STAFF REPORT AND RECOMMENDATION ON APPEAL

APPEAL NO.: A-6-ENC-00-193

PROJECT DESCRIPTION: Construction of an approximately 249 sq. ft. addition to an existing approximately 1,700 sq. ft. single family residence on an approximately 7,500 sq. ft. blufftop lot. The project also involves removal of existing unpermitted rip-rap at the toe of the bluff below the residence, and the request for after-the-fact approval of landscaping of the bluff face and grading of the blufftop area to direct runoff toward the street.

## GEOTECHNICAL REVIEW MEMORANDUM

Site Plan

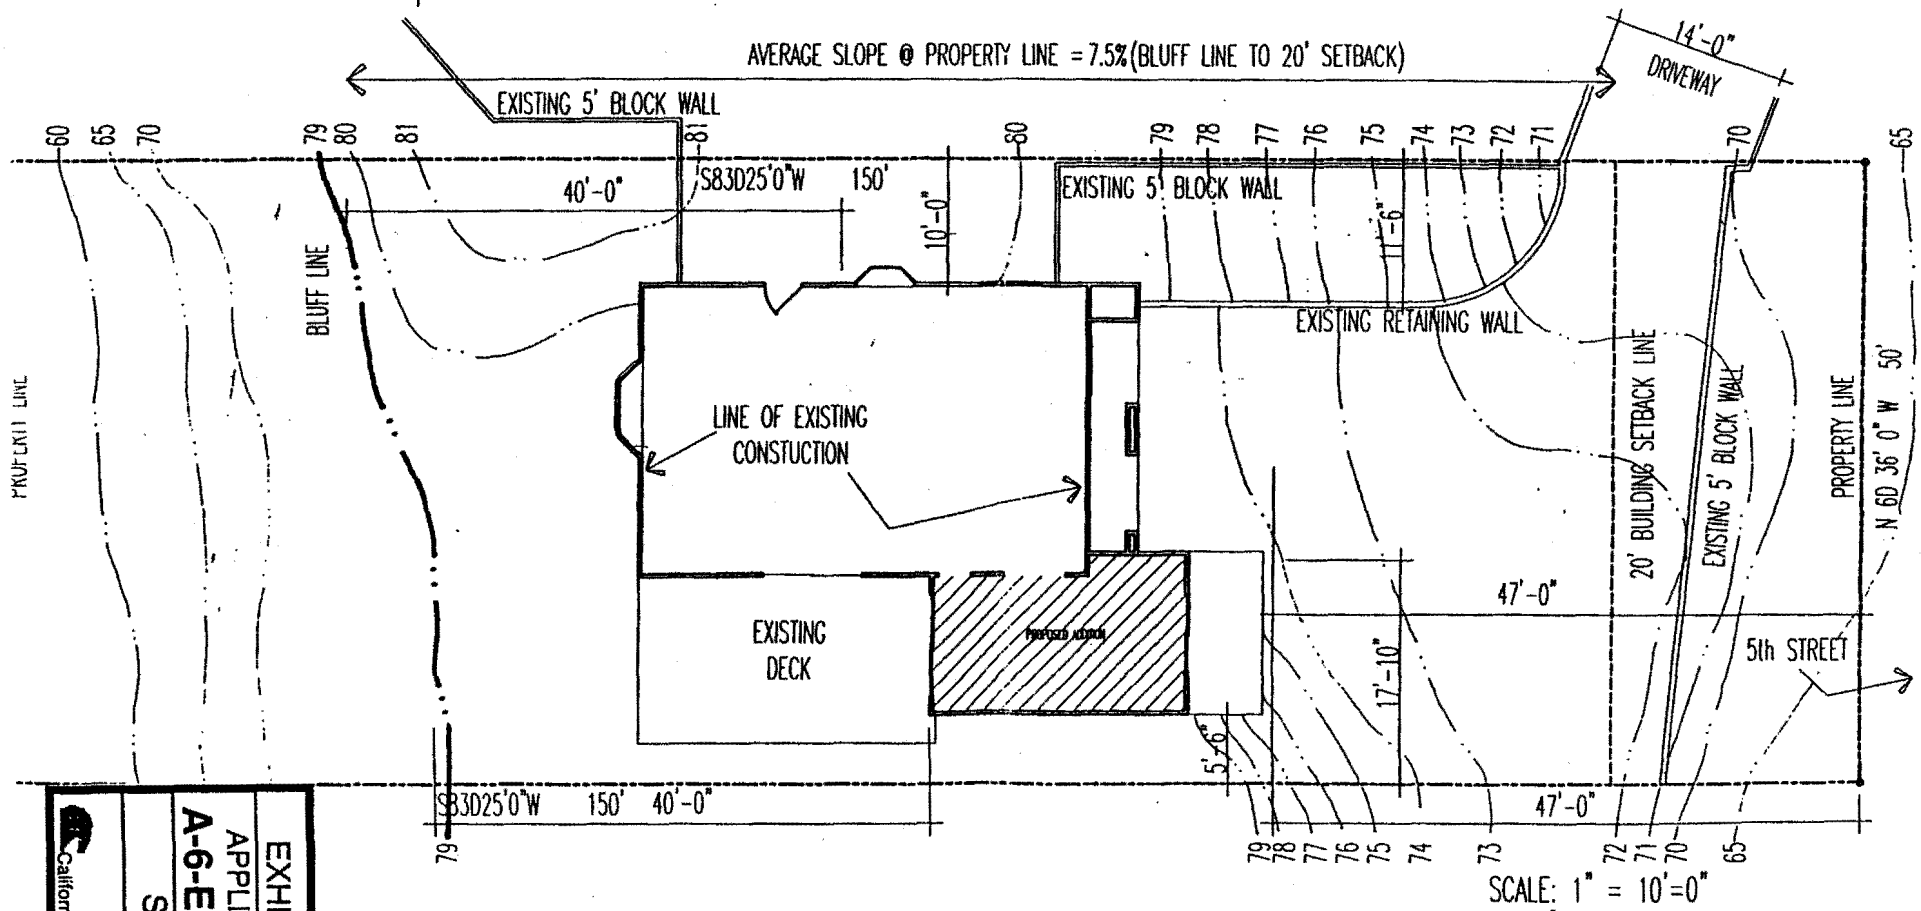
- a. All additions to the existing residence shall be limited to 250 sq. ft. or 10% of the existing residential square footage (which ever is greater) and shall be located no closer than 40 feet to the edge of the existing bluff.
- b. All runoff from the site shall be collected and directed away from the bluff edge towards the street.
- c. Existing accessory improvements (i.e., decks, patios, walls, etc.) located within 40 feet of the bluff edge shall be detailed and drawn to scale on the final approved site plan.

5. Open Space Deed Restriction No development, as defined in section 30106 of the Coastal Act shall occur on the subject property seaward of the edge of the bluff as shown in Exhibit 5 except for:

EXHIBIT NO. 3  
APPLICATION NO.  
A-6-ENC-00-193  
Elevations  
California Coastal Commission

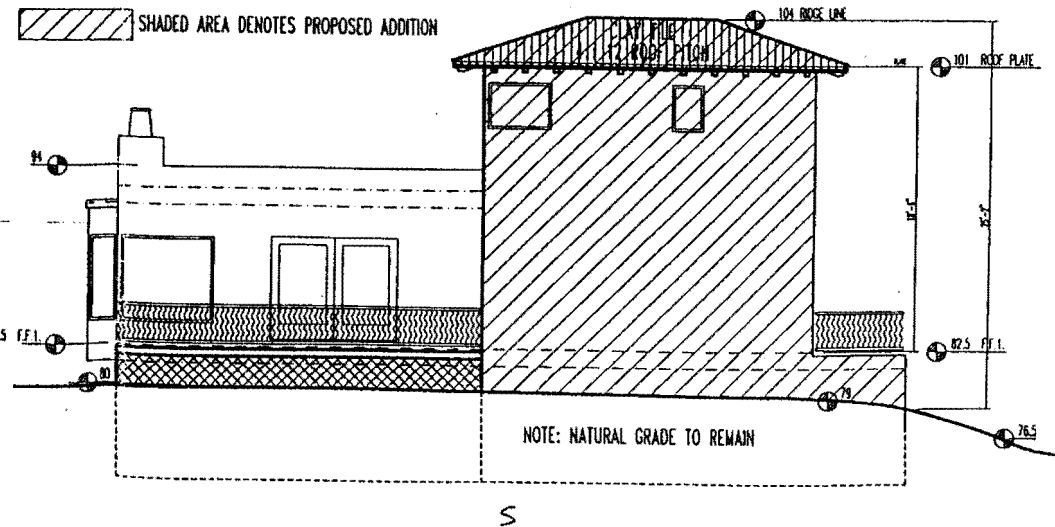
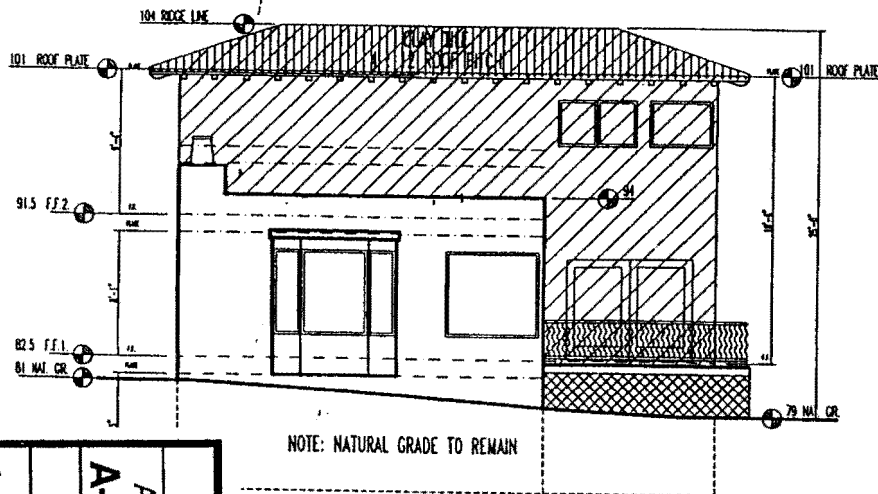
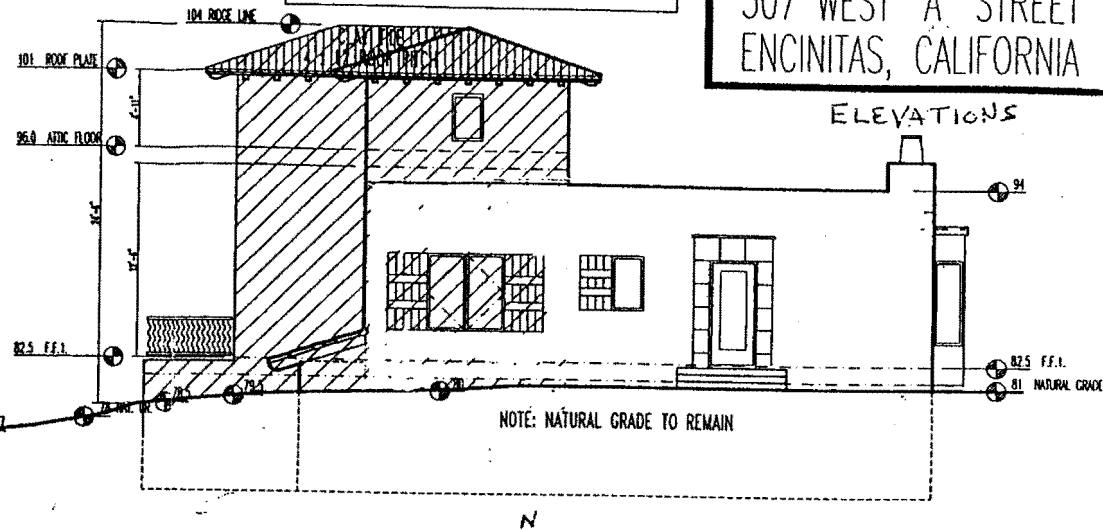
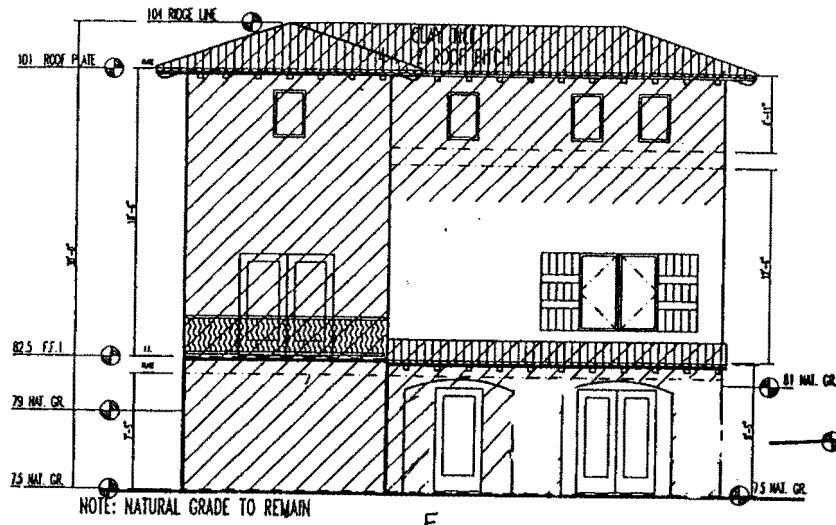
SHADED AREA DENOTES PROPOSED ADDITION

SITE PLAN

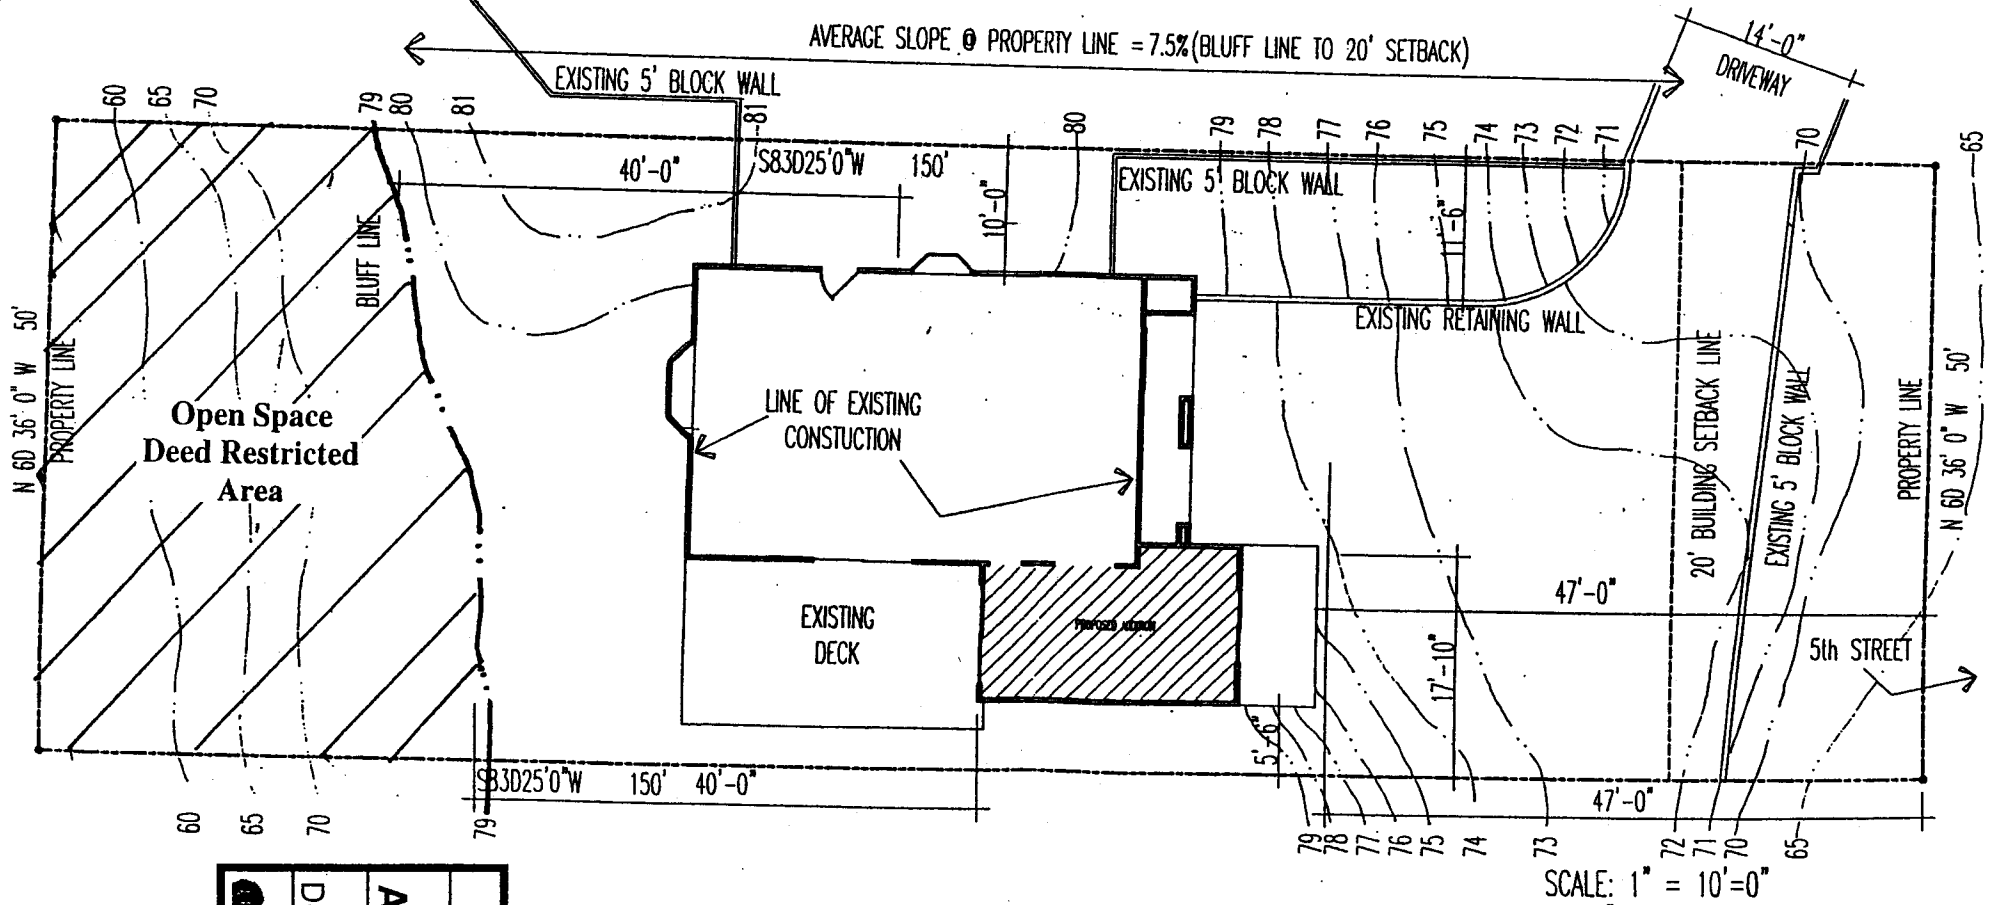
Because the bluff does not meet the stability standard required by the LCP, development must be set back behind the line on the bluff top where a factor of safety of 1.5 can be demonstrated. The position of the intersection of the line representing a factor of safety of 1.5 with the top of the bluff can be crudely scaled from the figure presented in reference (13), which I measure to be approximately 17 feet (cf. 21 feet scaled from reference 11).

A conservative approach to establishing setbacks might be to expect the bluff configuration to remain the same as at present over the course of its retreat. To ensure stability at the end of 75 years, the current setback required to assure stability might be added to the expected retreat. With the information available, it would appear that a 17 foot setback would assure stability with regard to failure of the upper bluff. To this figure should be added the expected bluff retreat on the basis of a 75-year design life (19 feet), for a total of 36 feet. One would generally require a buffer (typically ten feet) be added to the expected bluff retreat value in order to ensure that the foundation elements are not actually being undermined at the end of the 75-year period, to allow access for any remedial actions (such as foundation underpinning or relocation of the structure), to allow for an acceleration of bluff retreat rates over the historic rate due to anticipated acceleration in the rate of sea level rise, and to allow for general uncertainty in predicting geologic processes into the future. In this case, however, such a buffer may be absorbed by the buffer necessary to ensure stability against landsliding of the upper bluff. I note that the recommended setback is slightly less than the LCP-mandated 40-foot setback, and so the 40 foot setback requirement applies.
